FIRST AVENUE PROPERTIES REZONING

Technical Memorandum

CEQR No.: 06DCP039M

January 25, 2008

685 First Avenue
Building Massing
Figure 2

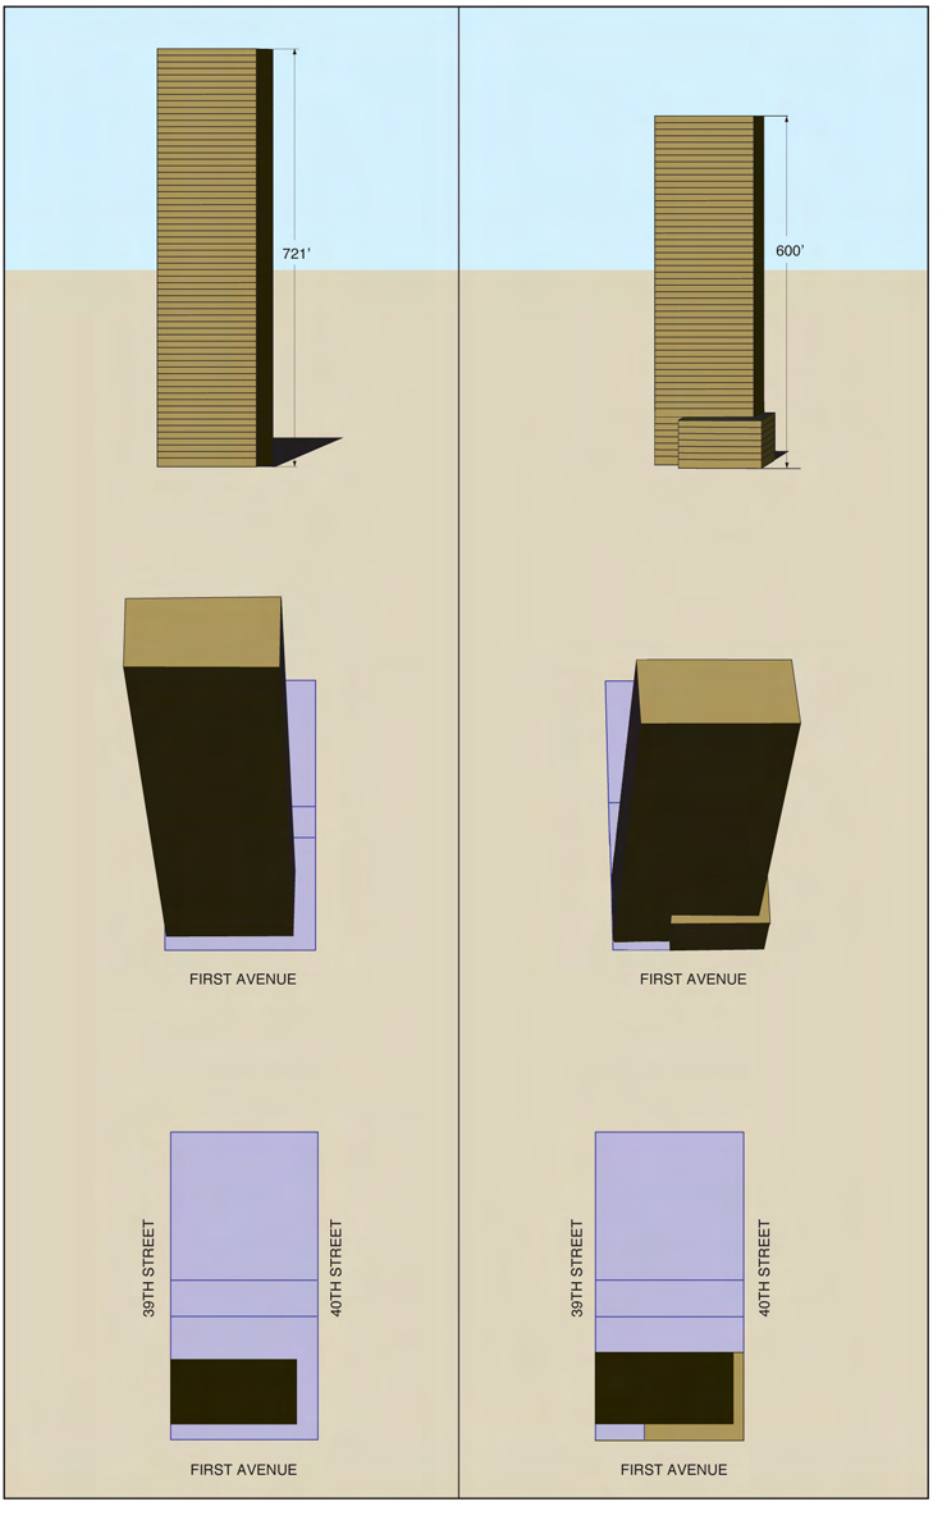
The proposed modifications would reduce the height and alter the shape of the building at 685 First Avenue (see Figures 2, 3, and 4). Specifically, the height would be reduced from a maximum of 721 feet to a maximum of 600 feet. In addition, the modifications would require a lower base portion of the building, 85 feet high, set within 5 feet of the property line on First Avenue and at the property line on the side streets; the tower would rise above this base. This change would create basically a lot line footprint, which would echo a similar footprint and street wall at Tudor City, just north of the site. In keeping with the continuous streetwall, the proposed modifications would require that 50 percent of the 685 building's frontage be occupied by retail establishments; the FSEIS proposal is for 33 percent of the frontage to be occupied by retail use. Under the proposed modifications, the building would have a 20-foot rear setback, but there would be no publicly accessible open space on the site; the FSEIS proposal included 0.17 acres of such open space on site. The setbacks would not provide for publicly accessible open space.

708 First Avenue Building Sections with Proposed Modifications Option 1

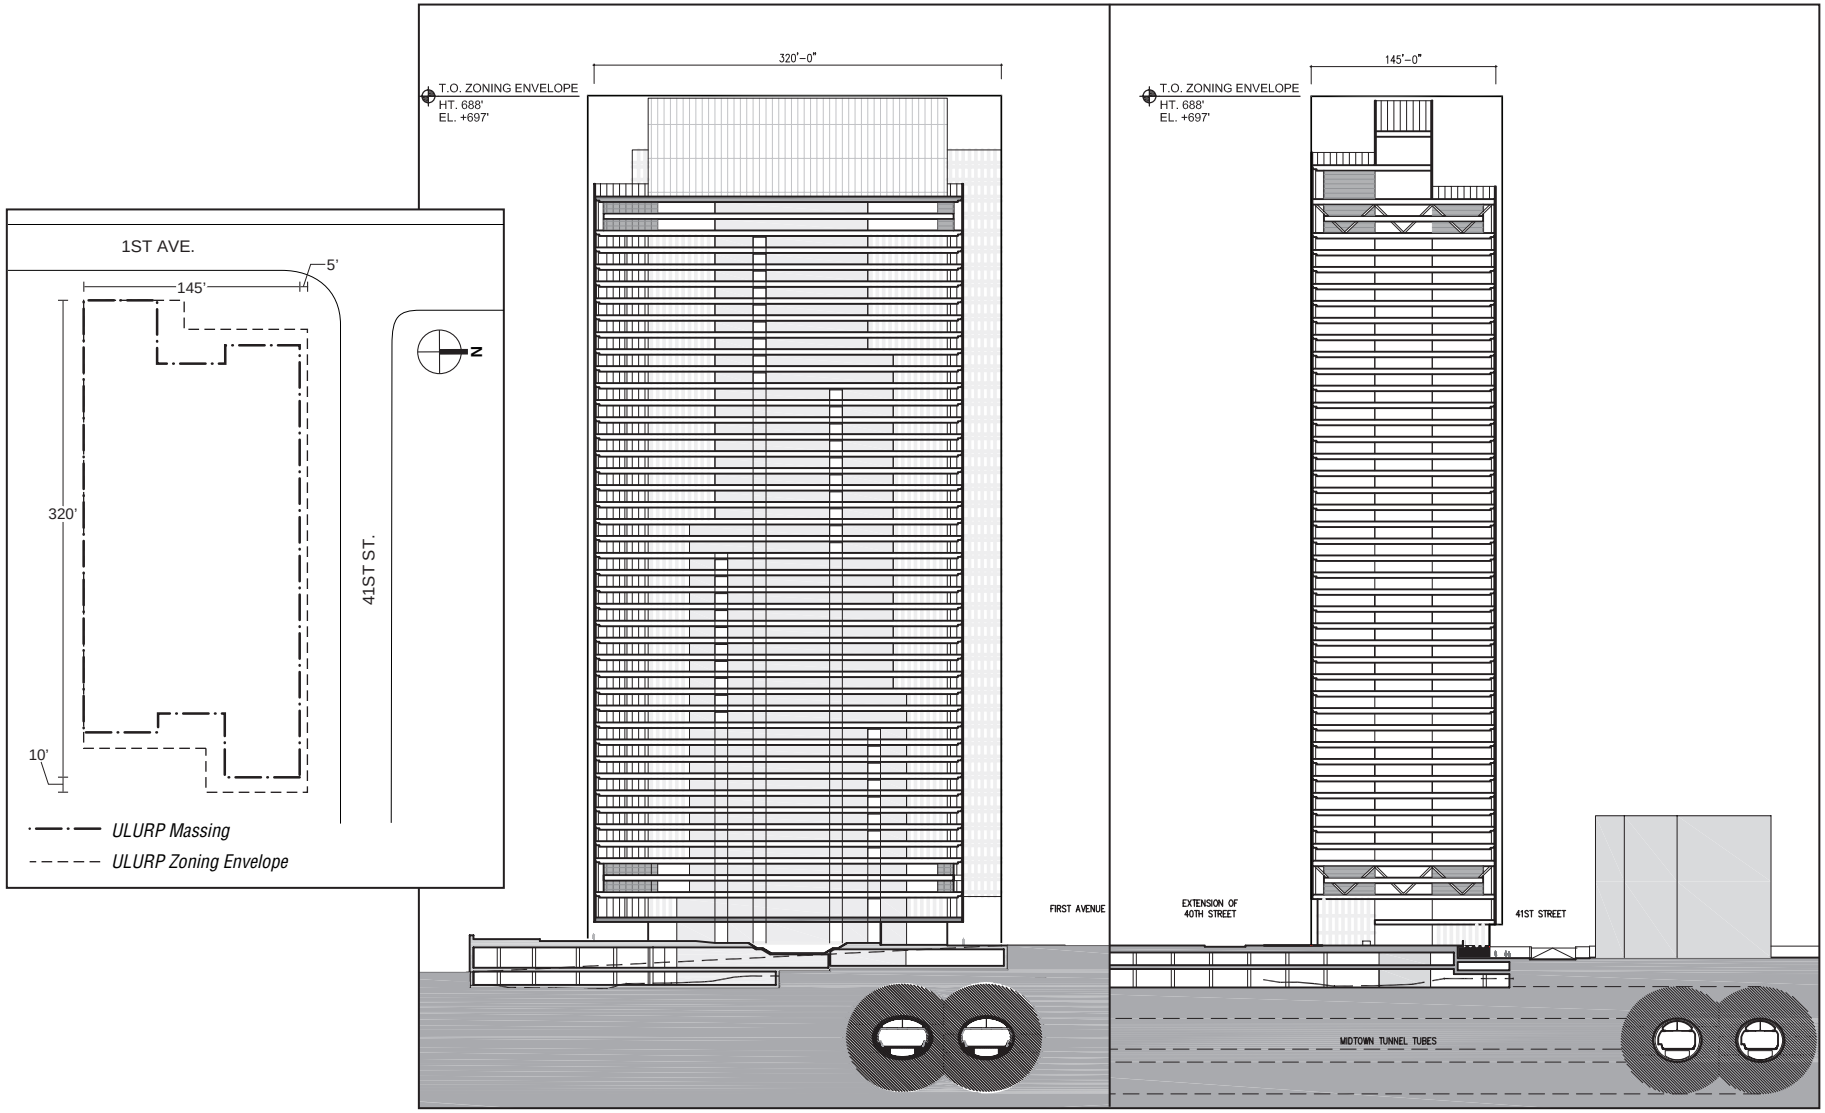
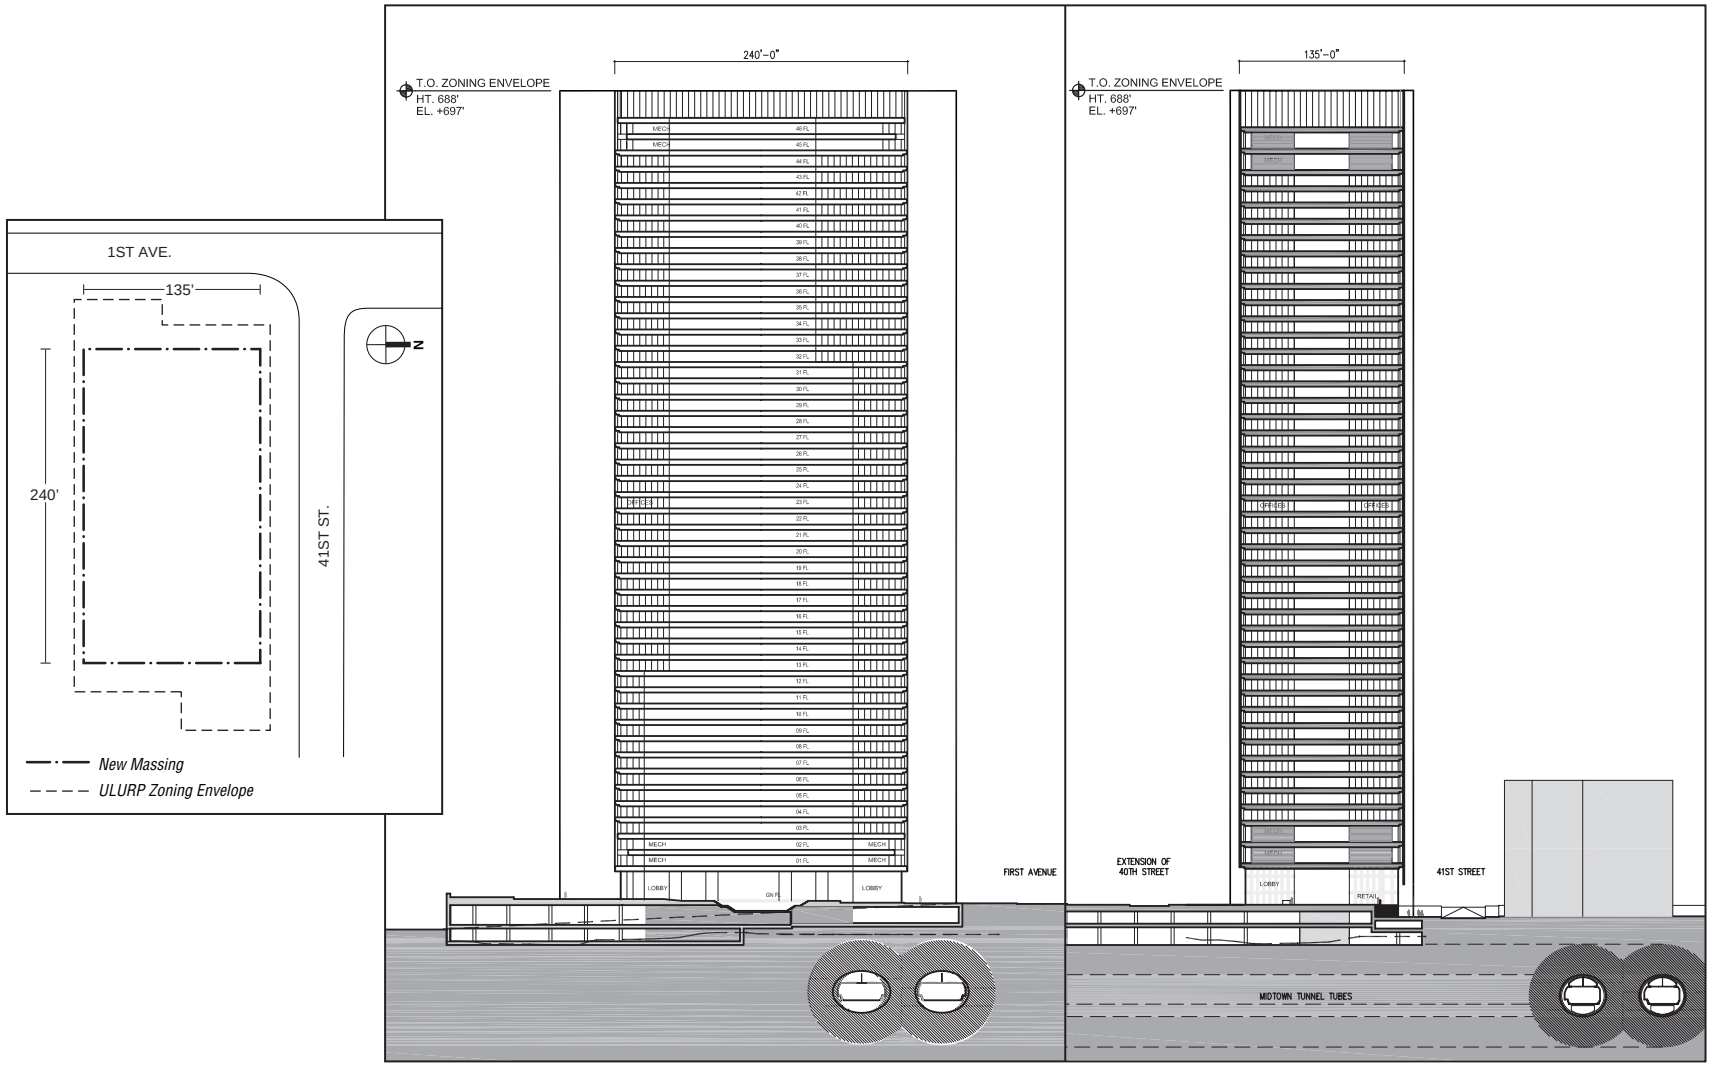
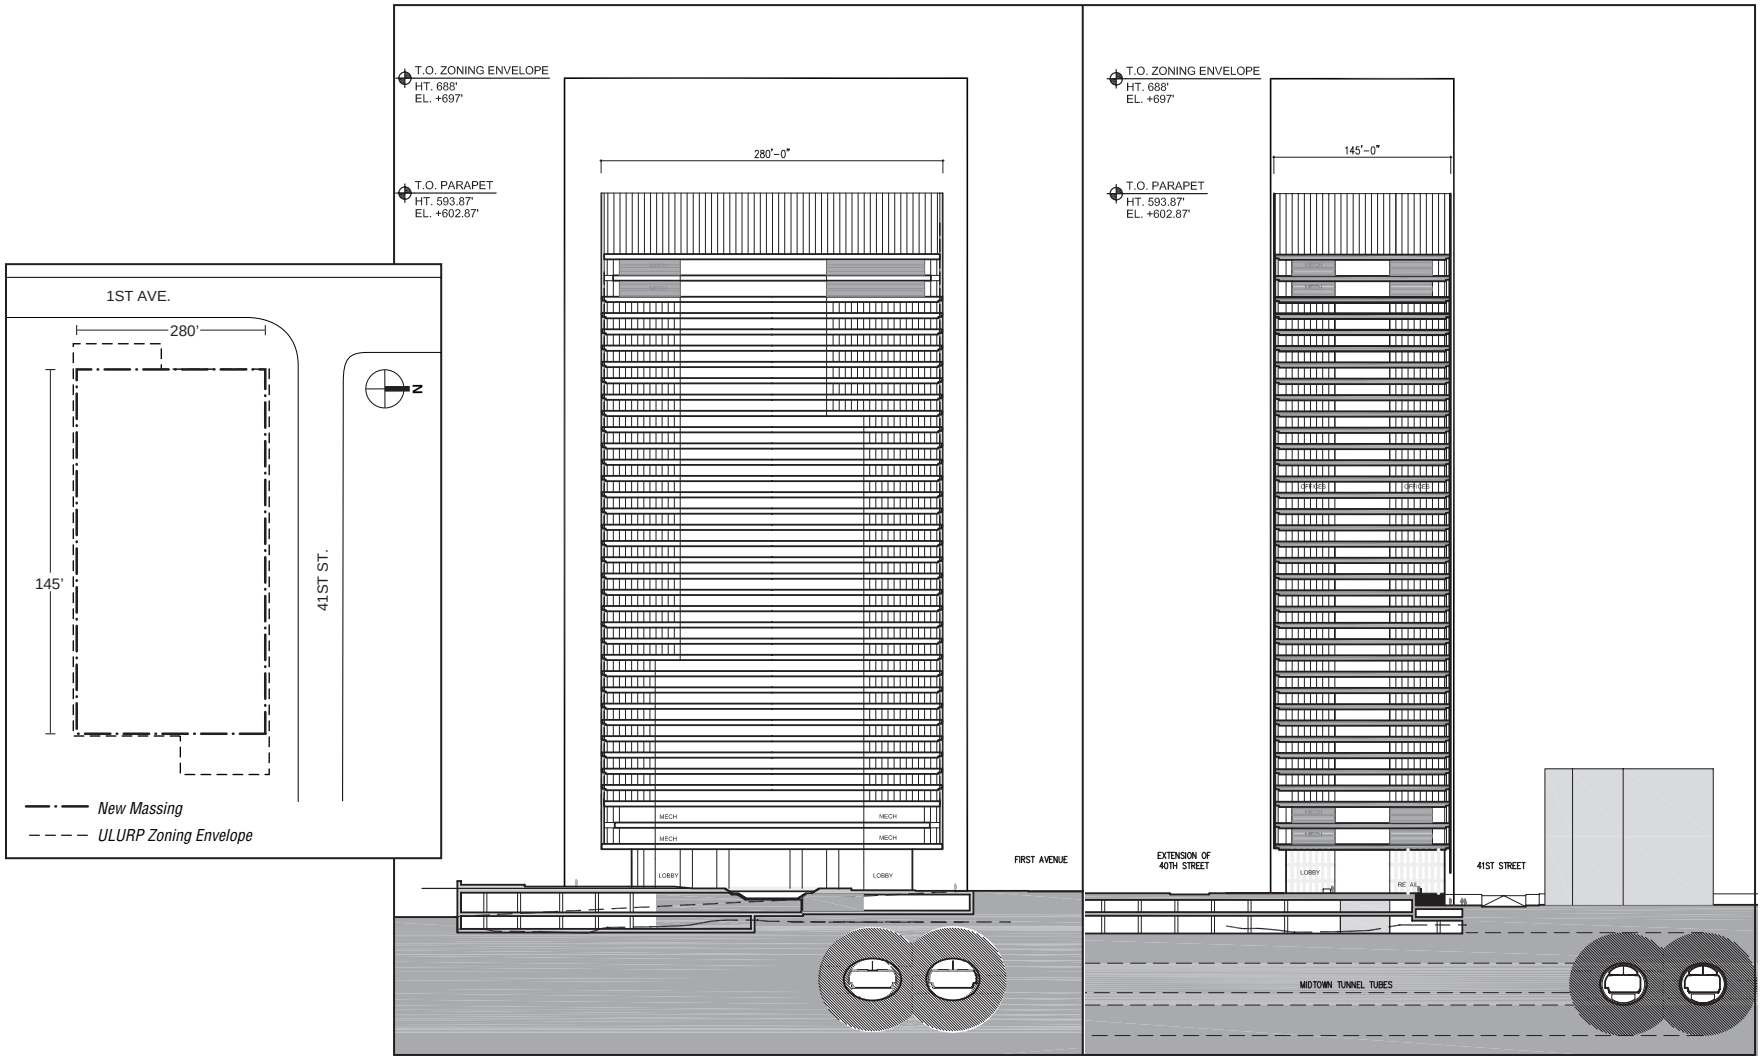
- The proposed modifications would decrease the allowable zoning floor area of the building at 708 First Avenue from 1.37 million square feet to 1.14 million square feet. This change would reduce the floor area ratio (FAR) from 12.0 to 10.0 at this site. In addition, the proposed modifications would reduce the overall length of the building footprint. As shown on Figure 5 the footprint proposed in the FSEIS has a configuration of two rectangles, oriented east-west, that are offset from one another, so that the combinations creates an east-west dimension with an overall length of 320 feet. Under the proposed modifications the building footprint would be a simple rectangle, which would reduce the overall east-west length of the building. The same maximum height of 688 feet shown in the FSEIS would be permitted under the proposed modifications.

This Technical Memorandum addresses two options for the 708 building; both options would have the same floor area, gross square footage, FAR and use; they would differ only in shape and height. Option 1 would reduce the building's height as well as its floor area by maintaining the same 145-foot building width as shown in the FSEIS (length would be reduced to 280 feet); and Option 2 would maintain the 688-foot height by reducing the building's footprint to 240 feet long (east-west) by 135 feet wide (north-south), as shown on Figures 6 and 7, respectively. The building height under Option 1 would be 594 feet; under Option 2 it would be approximately 688 feet.

616 First Avenue
Revised Site Plan
Figure 8

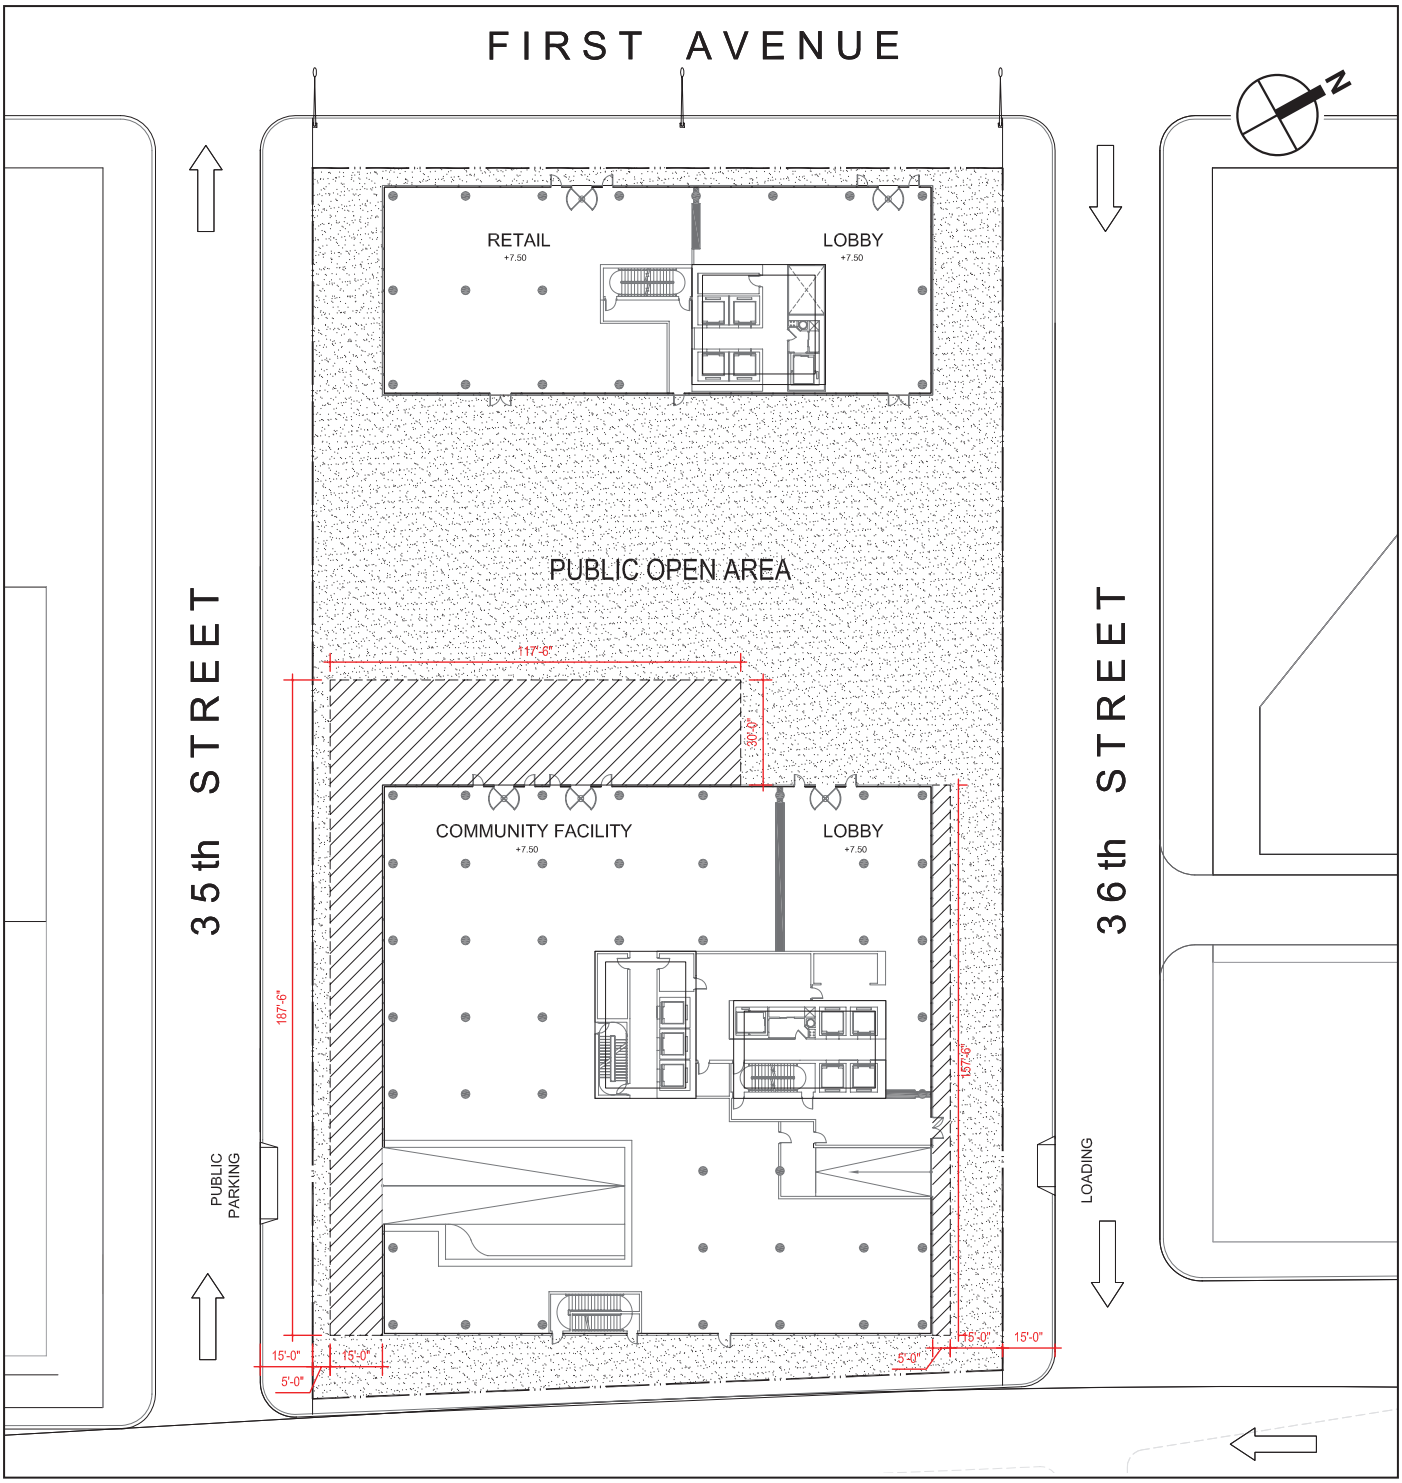
- This Technical Memorandum addresses a revision to the site plan at 616 First Avenue in connection with the new school. The FSEIS accounted for 119,936 square feet of community facility space as part of the eastern 616 First Avenue building (616-2); the mitigation chapter of the FSEIS assessed the construction and use of a portion of that community facility space as a 92,500-square-foot school. The site plan at 616 First Avenue has been revised since the FSEIS to further reflect the possibility that the school would be in a free-standing structure (see Figure 8). With the school housed in its own structure, the school floor area that was incorporated into the base of the tower at 616-2 would be moved outside the tower base. This adjustment of the 616-2 building footprint in conjunction with the revised school programming would require an estimated 6,673-square-foot reduction in the amount of publicly accessible open space (including an approximately 3,600-square-foot reduction in the widths of portions of proposed sidewalks along East 35th and East 36th Streets). In addition, the Early Childhood Center program (serving the youngest school children) may require approximately 3,000 square feet of open space on the ground floor. If so, this space would also come from area assumed to be publicly accessible open space in

**NOTE: Alternative zoning envelope shall apply and open space improvements in designated area shall be removed in the event that a school use occupies the community facility space. Alternative zoning envelope for 616-2 will comply with tower regulations of zoning resolution 23-65*

the FSEIS. Overall, the provision of a school on the site would reduce public open space on the 616 First Avenue parcel from 34,507 square feet (0.79 acres) in the FSEIS to 24,834 square feet (0.57 acres).
